ADDENDUM TO ADVERTISED CONTRACT

PROJECT NAME: TOWN OF BRASELTON 2021 LMIG ASPHALT RESURFACING PROJECT
PROJECT NUMBER: RFB #2021LMIG
CITY: TOWN OF BRASELTON
AMENDMENT NUMBER: 2
LETTING DATE: APRIL 9, 2021

TYPICAL SECTION

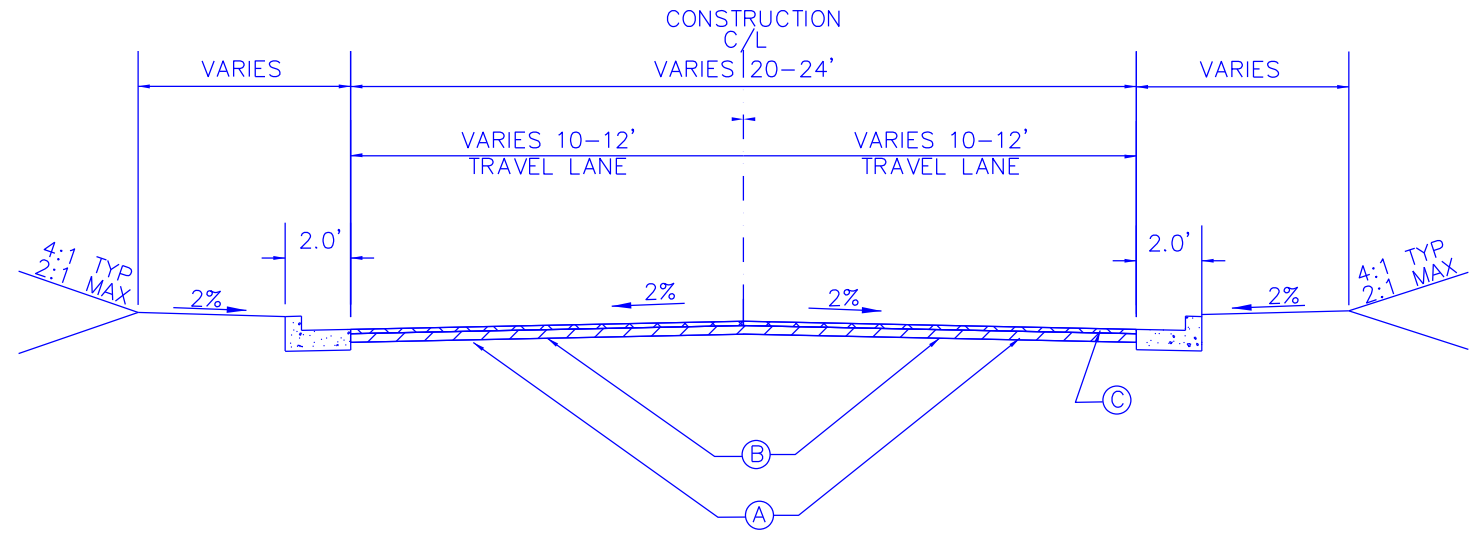
1. See attached clarification of Typical Section for Mulberry Park Drive & Park Bend Drive

- A. MILL ASPH CONC, 3" DEPTH
- B. 220 LB/SY RECYCLED ASPHALT CONCRETE 19 MM SUPERPAVE OVERLAY
- C. 135 LB/SY RECYCLED ASPHALT CONCRETE 9.5 MM SUPERPAVE OVERLAY
